Project Title:	Holme Park SANG, South Wokingham SDL
Project No/ Document Reference:	A389 R021B
Date:	13 August 2026
Author:	Rebecca Fletcher

HOLME PARK SANG

1. Condition discharge

Figure 2 Extract from Site Overview Surface Water Strategy A389-001

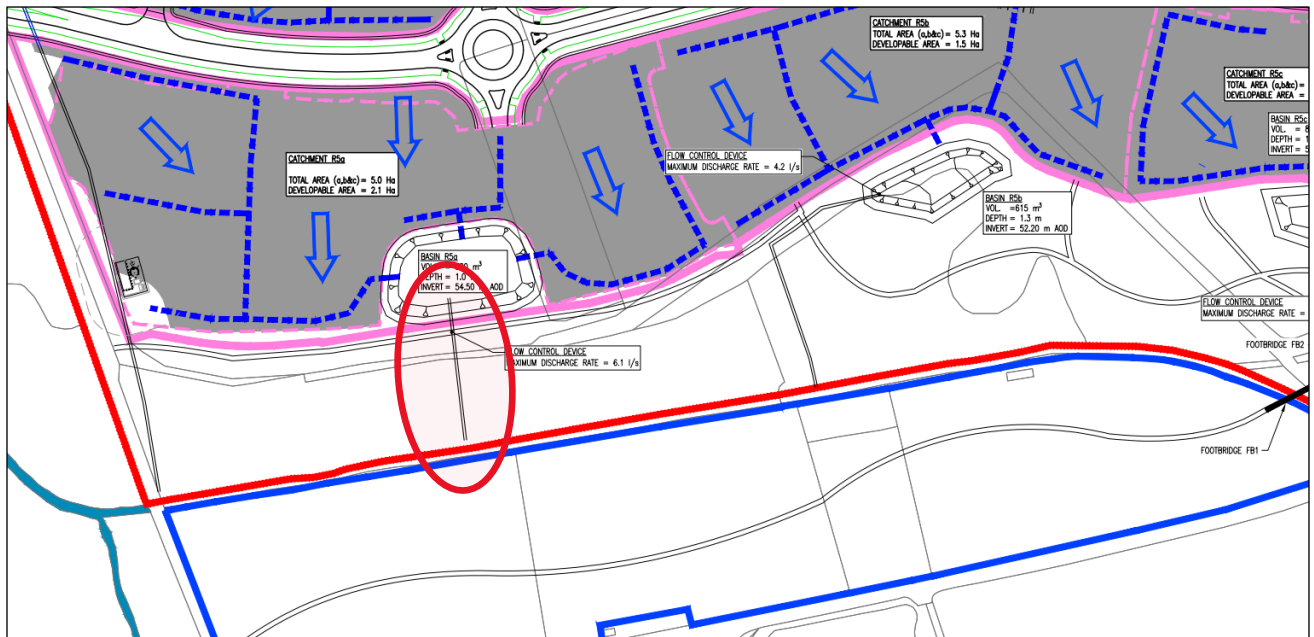
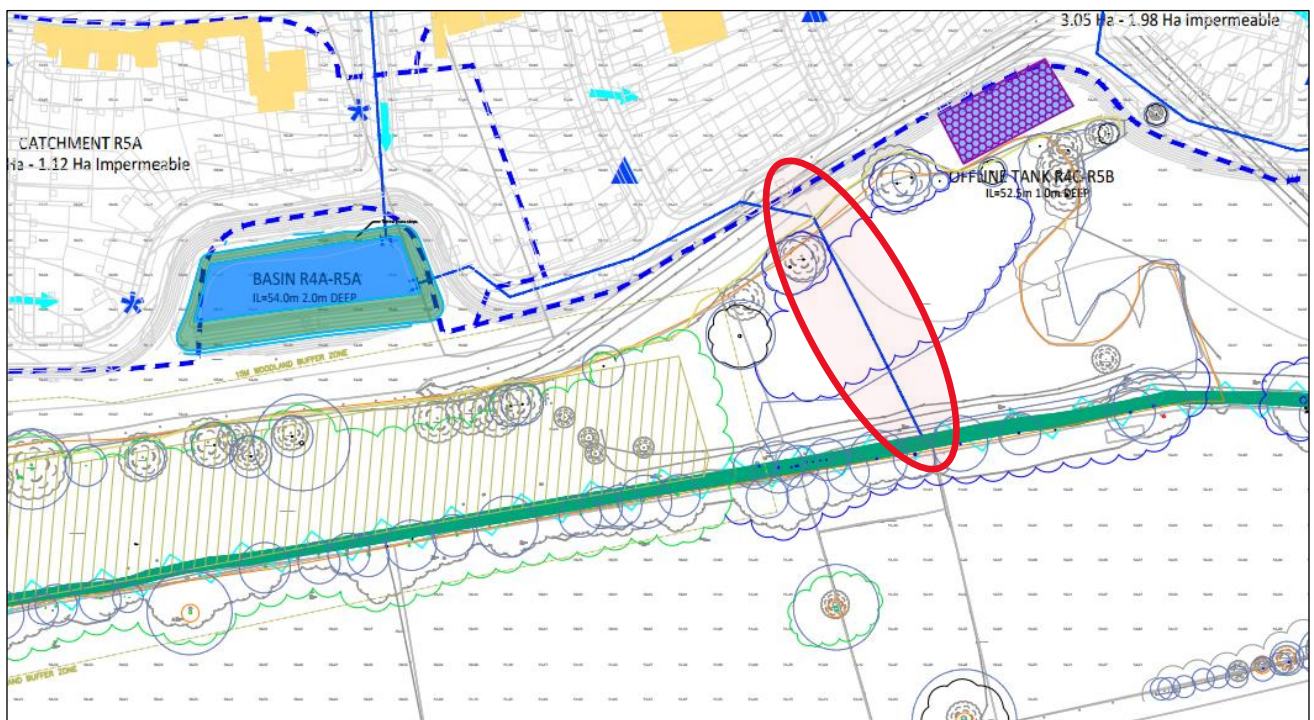
- 2.2. This relates to the connection from attenuation basin R4A-R5A, located north of the SANG, to the Emm Brook to the south. In the Flood Risk Assessment submitted for the outline planning consent, the connection was shown running directly through the woodland. Refer to extract below from drawing 70001684-D-003.

2.3. Since the production of the FRA, the surface water drainage strategy has been developed and this connection has been amended to ensure the pipe route between the basin and the Emm Brook is located further east, outside the boundary of the semi-natural ancient woodland. Refer to extract below from drawing A389-001 Site Overview Surface Water Strategy.

- 2.4. The pipe route will cross the northern path. Construction of the pipe is envisaged to be a through traditional open trench methods and will be subject to detailed design pursuant to the reserved matters application for Parcel R5. The proposed pipeline will be subject to an arboricultural impact assessment and works would be undertaken in accordance with the recommendations provided. This will require local, temporary closure of the path with a temporary diversion being put in place during the works. This will be undertaken during phase R4.0.2.
